SCS ENGINEERS

Subject: Response to RAI #1, Dated February 29, 2016
Application for Renewal of a Solid Waste Operation Permit
Vista Landfill, Class III (WACS ID NO: 87081)
Apopka, FL

FIGURE 3. VICINITY MAP

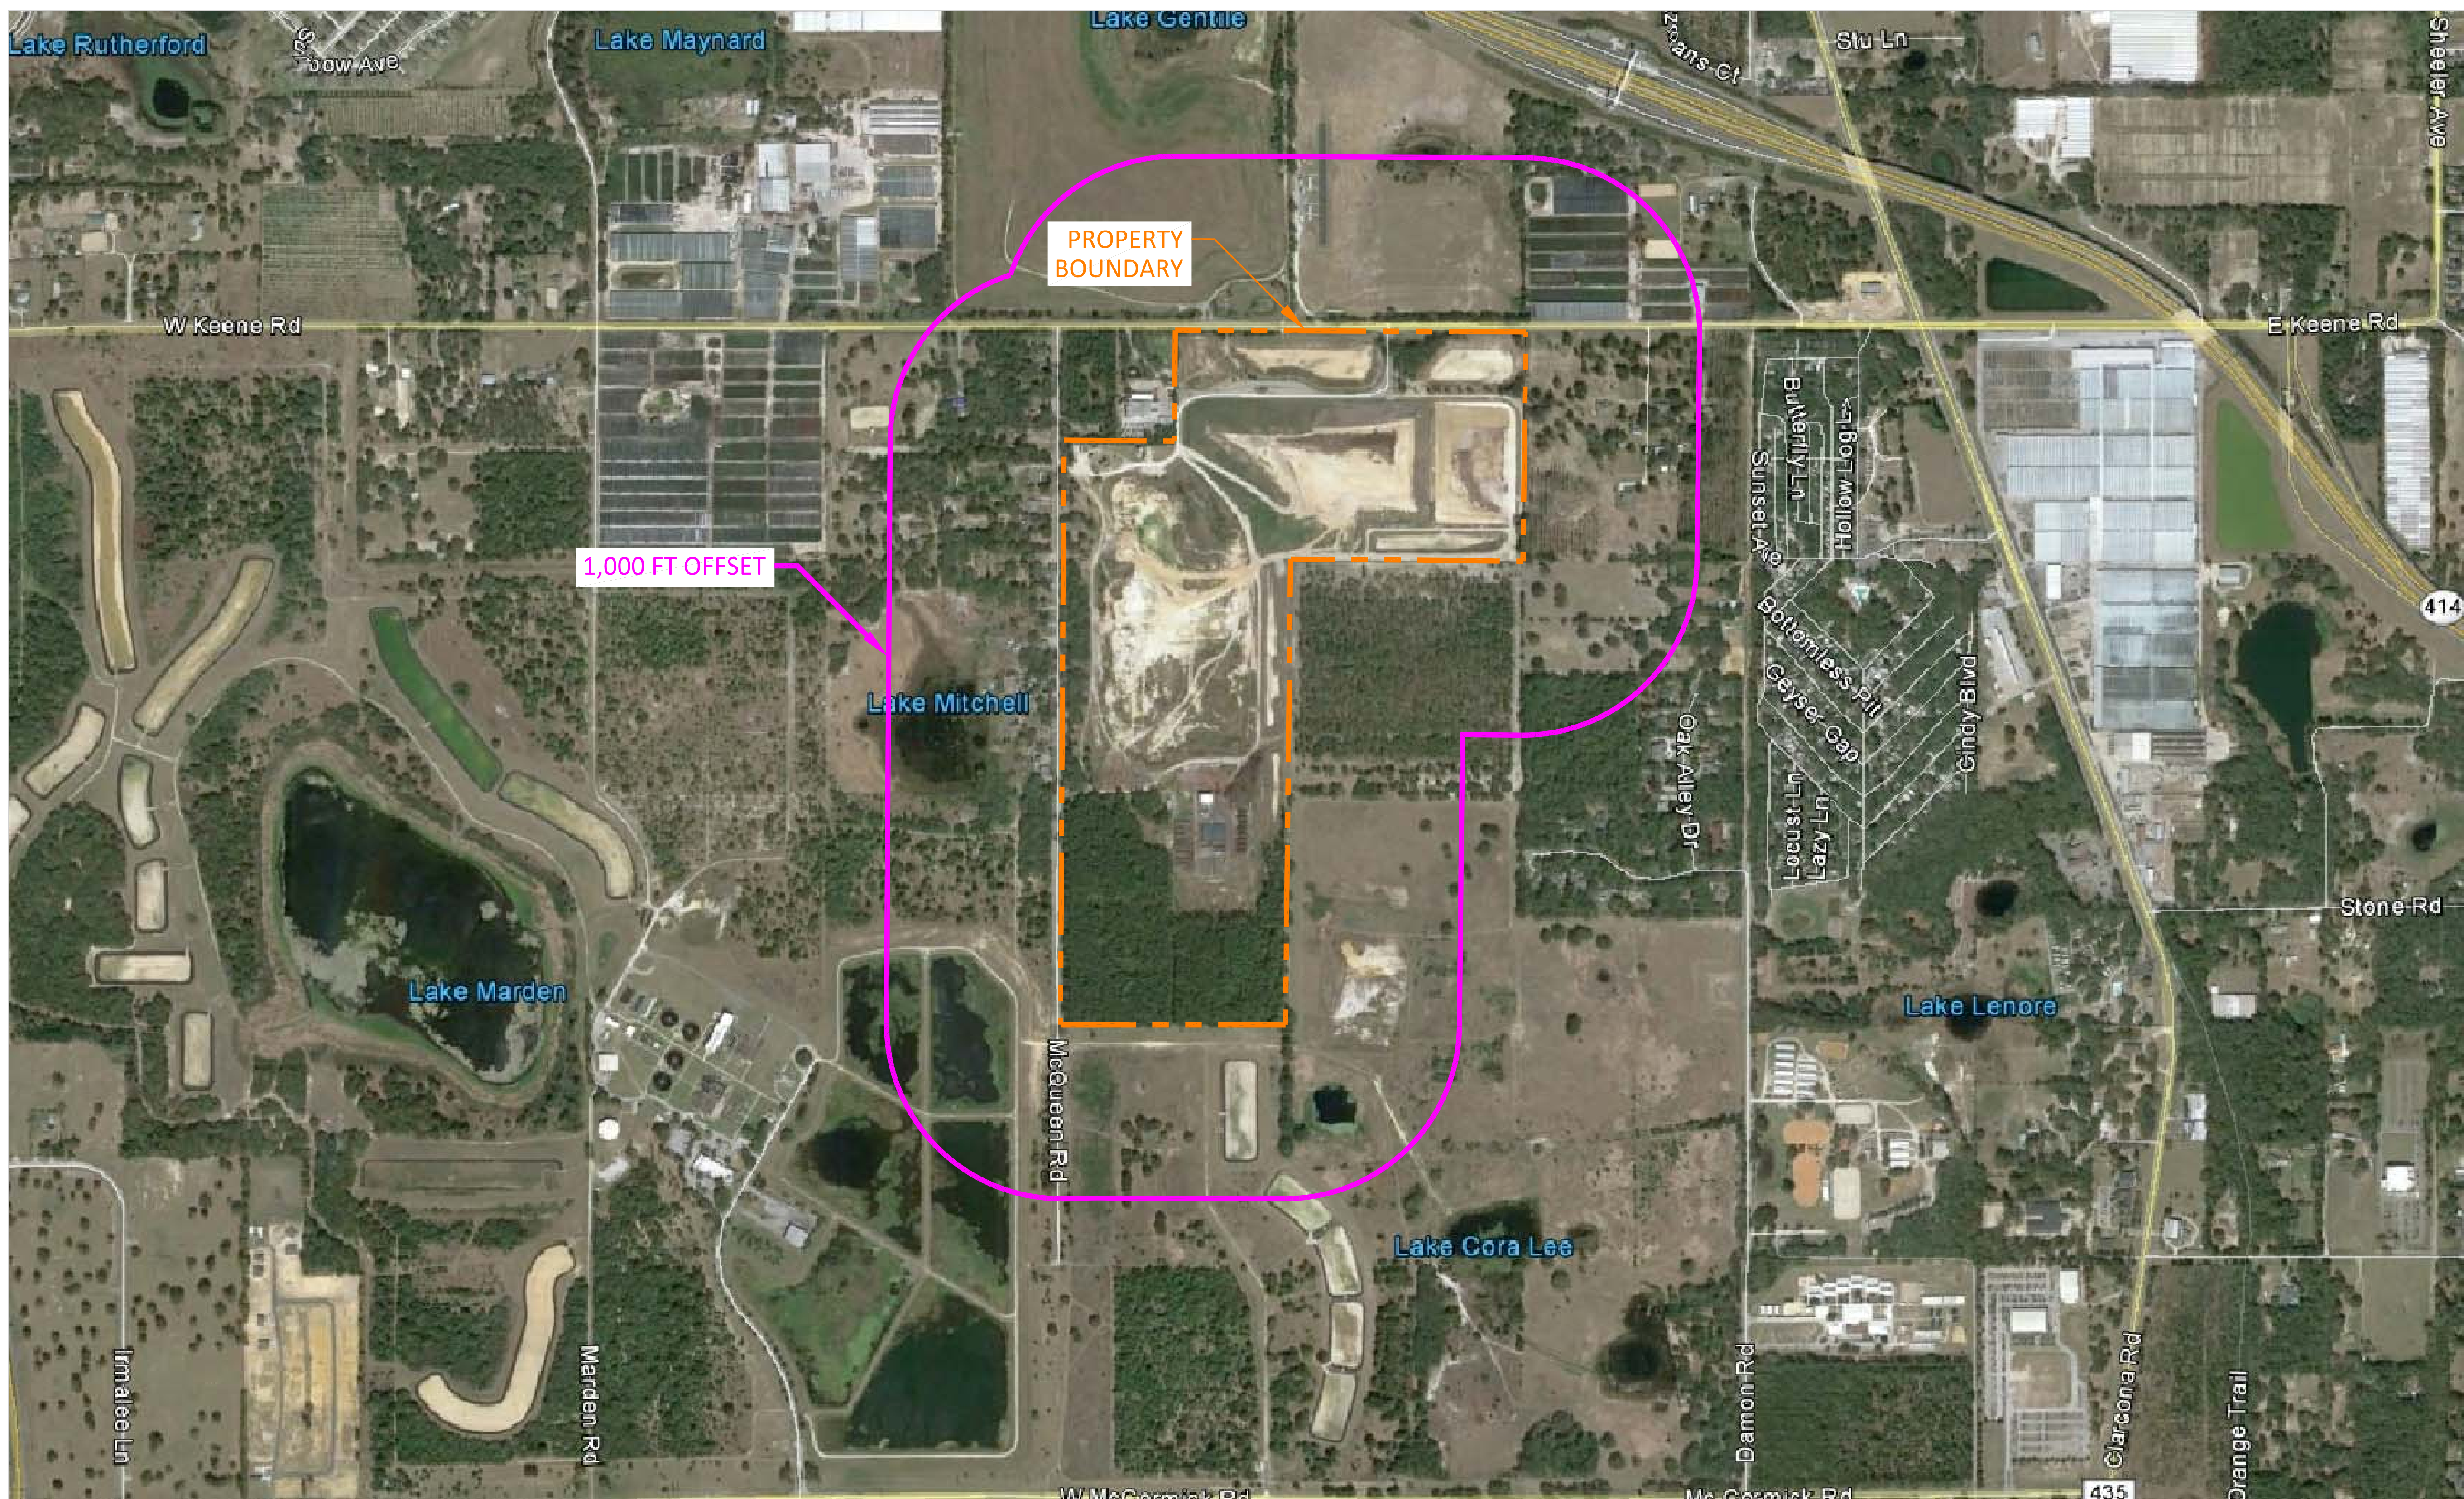
- ii. Page 14, Part D.9.b, A vicinity map or aerial photograph no more than one year old showing the facility site and relevant surface features located within 1,000 feet of the facility. Although marked as N/C, an aerial photograph was provided on page 42. Is it supposed to meet this requirement?**

- 1. The aerial photograph does not have a date to ensure it is less than one year old.**
 - 2. There is no scale to indicate it shows the vicinity within 1,000 feet of the facility.**

- 3. If the aerial photograph on Page 42 is the current document, please provide the reference information to the document being relied upon.**
 - iii. Page 14, Part D.9.c. A site plan showing all property boundaries certified by a Florida Licensed Professional Surveyor and Mapper. Although marked as N/C, a site plan was provided on page 43. Is it supposed to meet this requirement?**

As requested, an updated vicinity map showing the facility site and relevant surface features on a recent aerial photograph is presented in Attachment RAI #1 – D.

NOTE:
1. THE PROPERTY BOUNDARY SHOWN IN THIS DRAWING WAS SUPERIMPOSED ONTO THE AERIAL MAP AT ITS APPROXIMATE LOCATION FOR PRESENTATION PURPOSES. AERIAL PHOTOGRAPH DATE: MARCH 5, 2016.
